**SAFETY DEFECT AND NONCOMPLIANCE REPORT GUIDE FOR VEHICLES
PART 573 - DEFECT AND NONCOMPLIANCE REPORT¹**

On May 4, 2011, Nova Bus decided that a defect which relates to motor vehicle safety) (a noncompliance with Federal Motor Vehicle Safety Standard No. ____) exists in items of motor vehicle equipment listed below, and is furnishing notification to the National Highway Traffic Safety Administration in accordance with 49 CFR Part 573 **Defect and Noncompliance Responsibility Reports**.

Make(s): Nova Bus **Model year(s):** 2009-2011 **Model(s):** Nova LFS

Fig. 1 – Location of Drag Link Ends

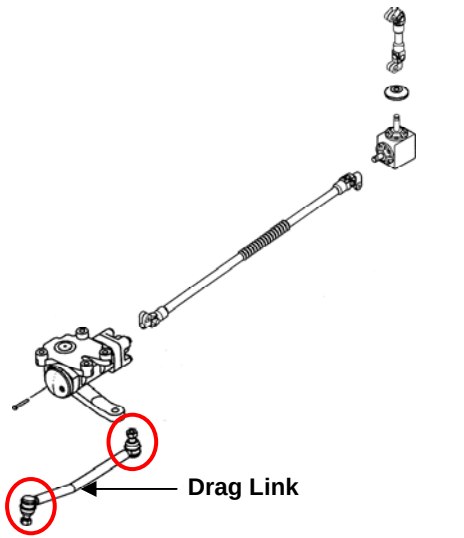
An insufficient torque was applied on the drag link ends during production. The drag link, connected to the pitman arm of the steering gearbox, is a part of the steering linkage. See Figure 1 for the location of the drag link ends.

The specification were not observed and the wrong torque was applied by workers.

The drag link may get detached for the steering linkage, causing a loss of control of the vehicle and possibly an accident. Such an occurrence could cause serious damage to the vehicle, and most importantly, injure anyone inside the vehicle (passengers, driver) or anyone close by (motorists, pedestrians, etc.)

A torque of 133 ± 15 Lb ft (180 ± 20 N•m) has to be applied to the nuts.
